Rings Scenic Tours Ltd - Development Concept Plan Updated Transportation Review

Matamata-Piako District Council

ISSUE 2, 11 MARCH 2019

Figure 3: Crash Diagram for Buckland Road (east)

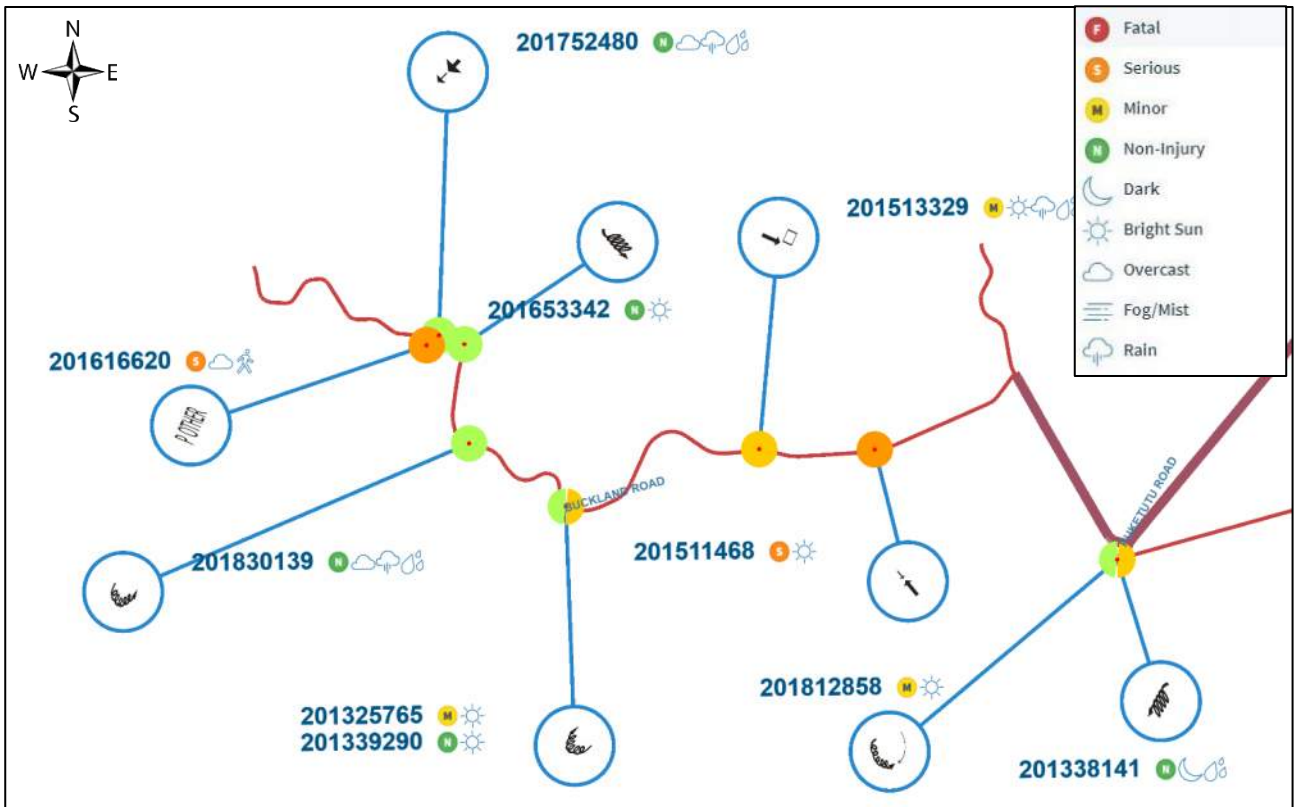
To assist us in our review we have retrieved crashes for the period 2013-2018. The crash diagrams are provided below, with more details provided in Appendix A.

Figure 4: Crash Diagram for Buckland Road (west)

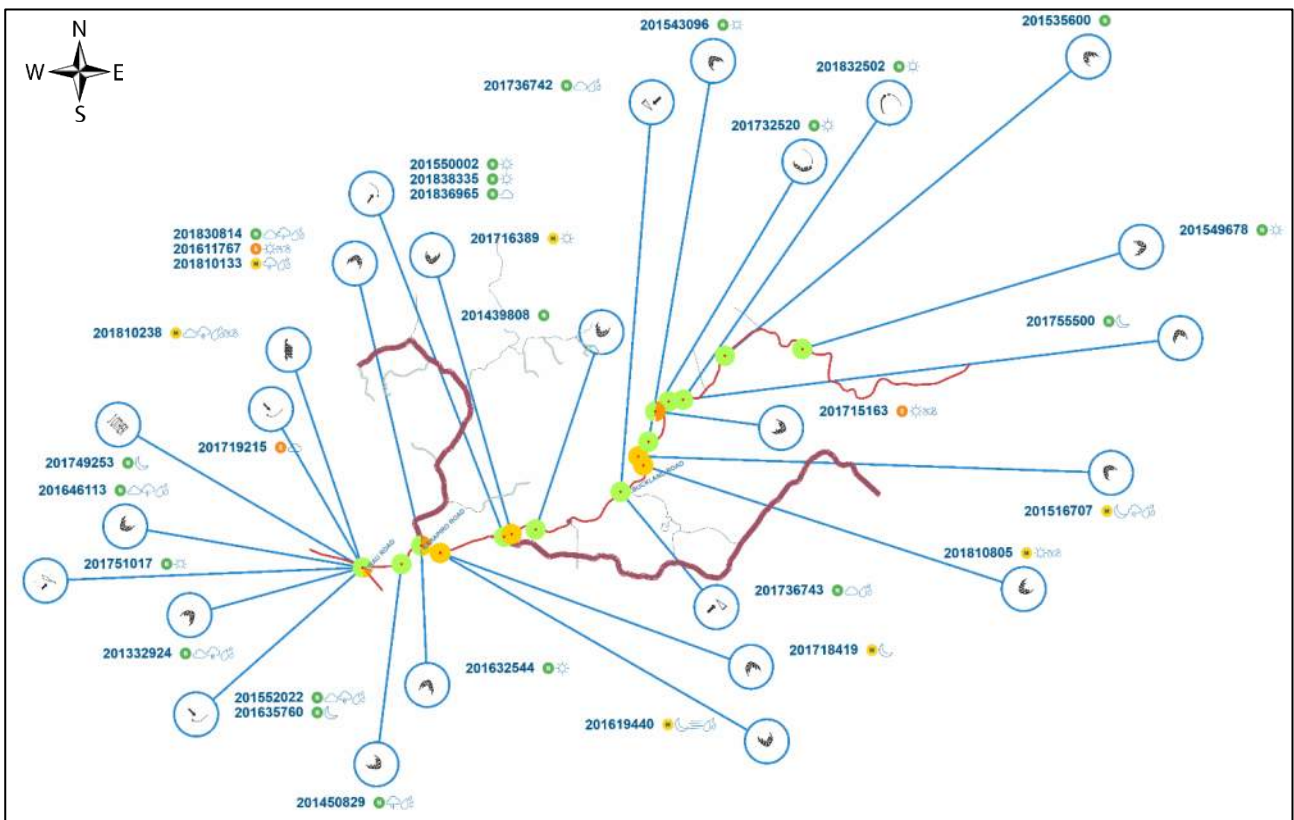
- = 11 of the 31 crashes (35%) occurred at intersections including eight at the Karapiro Road/ SH1 intersection;
- = 16 crashes (52%) were single vehicles losing control;
- = Two crashes involved vehicles hitting a fallen tree (in the same incident); and
- = Two crashes were head-on crashes on corners.

Both the head-on crashes occurred on a narrow section of Buckland Road where the centreline is already marked.

Figure 9: Potential No-Stopping Markings – 21 Buckland Road

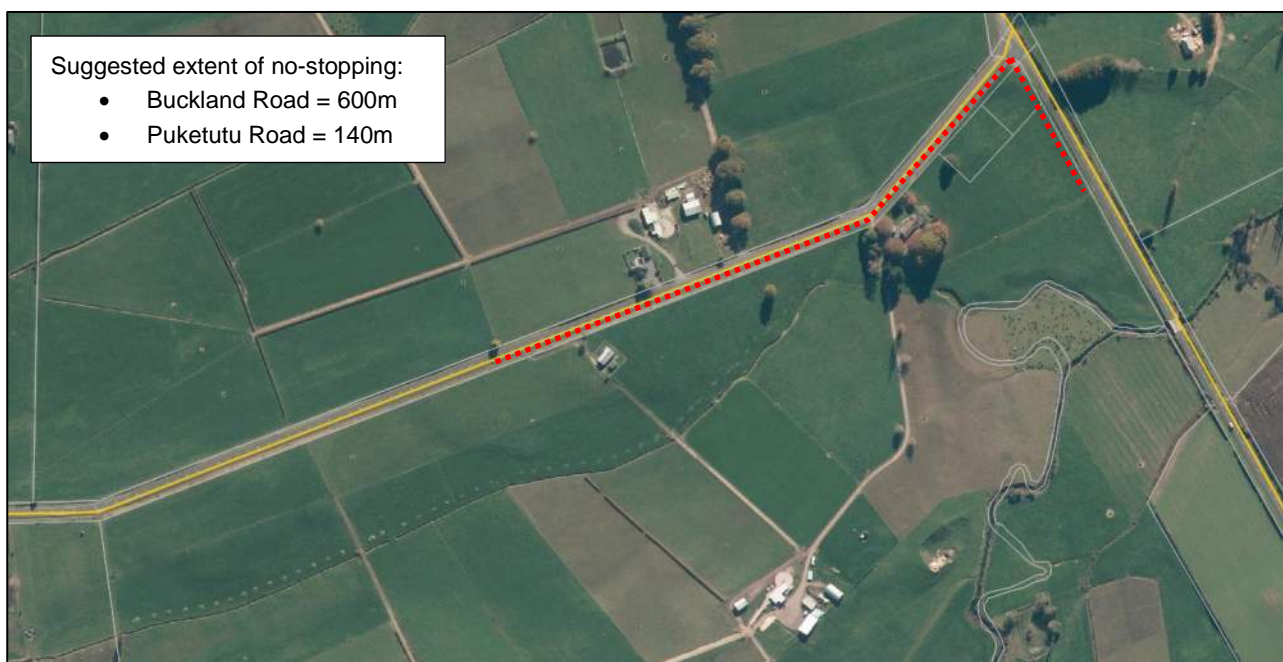
We understand that the owners of 21 Buckland Road have amenity, privacy and biosecurity concerns about drivers parking in their driveway. There do not appear to be any specific transportation (safety or efficiency) effects from this type of driver behaviour, marking no-stopping lines and erecting sign along their property frontage may assist in reducing amenity effects. A security gates should minimise biosecurity concerns.

There are no destinations or features that should lead to demand for on road parking in this area. It is possible that drivers are stopping to reconfirm directions or take photos. This could be minimised by installing a new direction sign or relocating an existing sign closer to the intersection. This would provide visitors with confirmation that they are on the correct route.

There would be no adverse transportation effects from marking no-stopping lines and erecting signs as indicated in the figure below. Installing additional no-stopping lines and signs would require additional parking enforcement by Council.

Figure 10: Splitter Island Concept

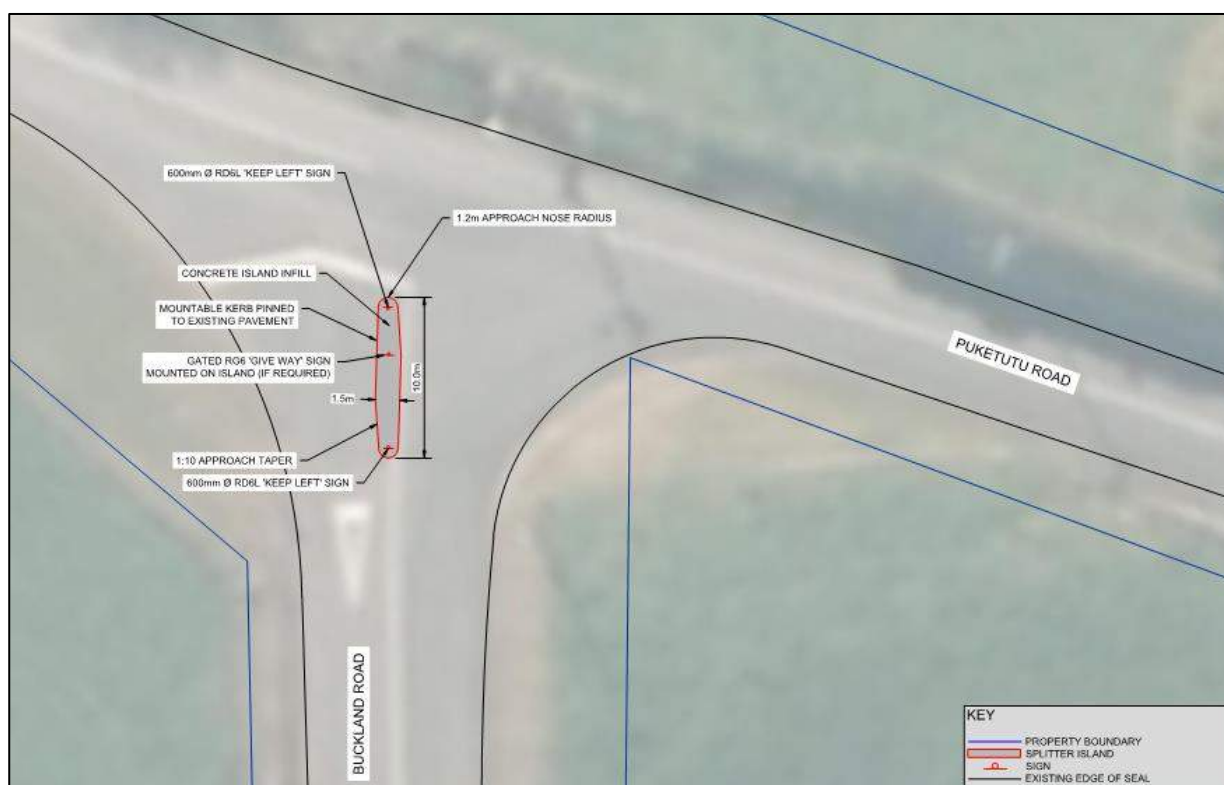
Submitters state that there have been loss of control crashes at the intersection, as a result of vehicle turning left from Puketutu Road in Buckland Road. In 2014, there were two reported non-injury crashes within 250m of the intersection, both involved vehicles losing control while turning left into Buckland Road and hitting the fence. On a recent site visit (1 February 2019) we observed one vehicle miss the left-turn into Buckland Road and u-turn on Puketutu Road before continuing on towards Hobbiton. Typical crash rates and intervention strategies generally take account of under-reporting of crashes¹.

Options to improve the conspicuity and layout of the intersection include:

- = Modifying the advanced signage and line marking.
- = Realigning the Buckland Road approach so that it is perpendicular to Puketutu Road. This would assisting in managing vehicle speed and improve visibility. This will require land purchase.
- = Providing a splitter island on Buckland Road – would reduce speed of vehicles turning right from Buckland Road into Puketutu Road and vice versa.

Figure 11: Additional Chevron and Speed Advisory Signs

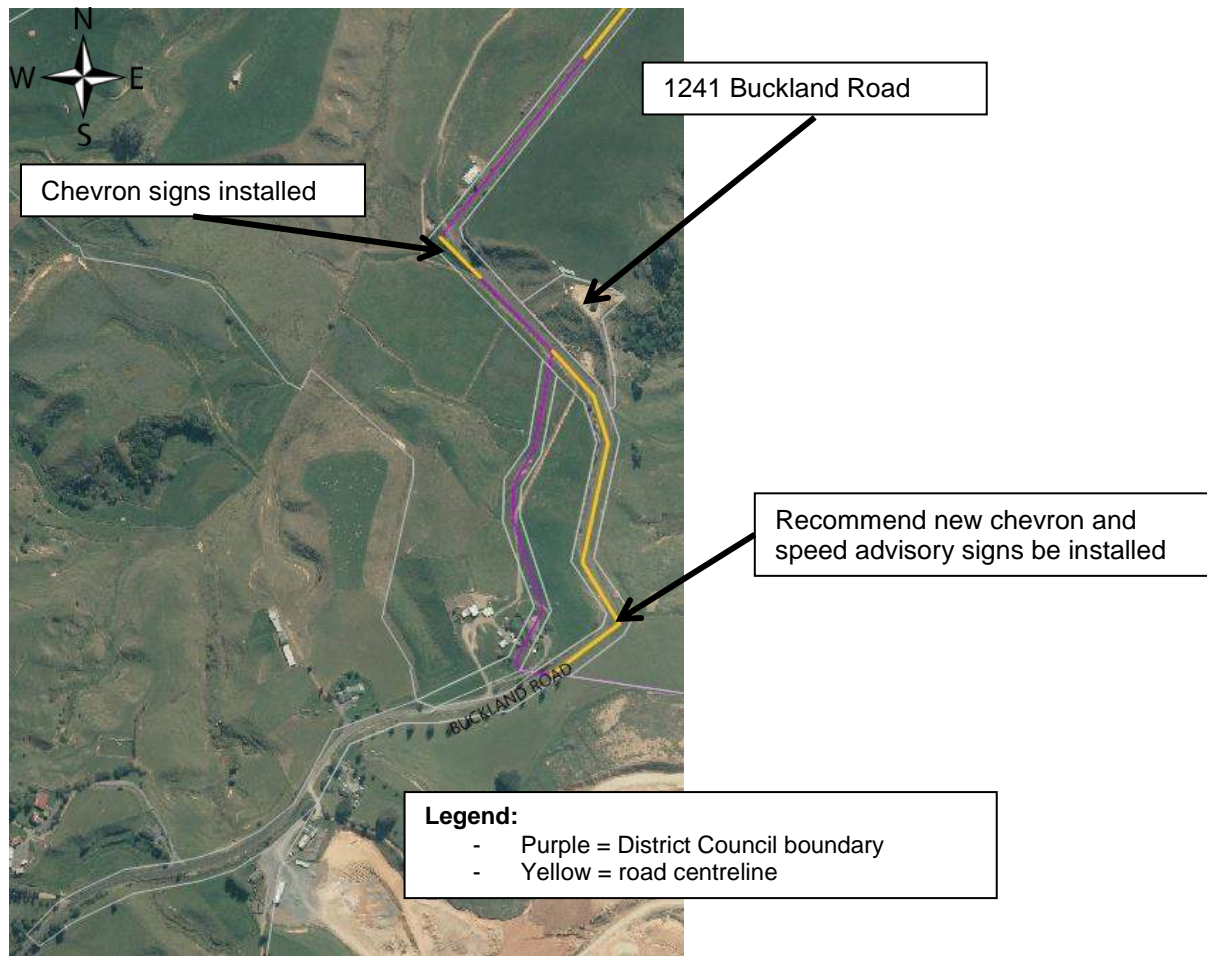
The crash data indicates a history of crashes at curves located near 1241 Buckland Road, including a minor injury crash in 2018⁶. In our experience, visitors are still using Buckland Road (west) to travel to the site and this is supported by the traffic counts. Based on the road alignment (curve radius

48m⁷) these curves are out of context with the approaches. We recommend that additional chevron and speed advisory signs are installed at the location shown on the figure below.
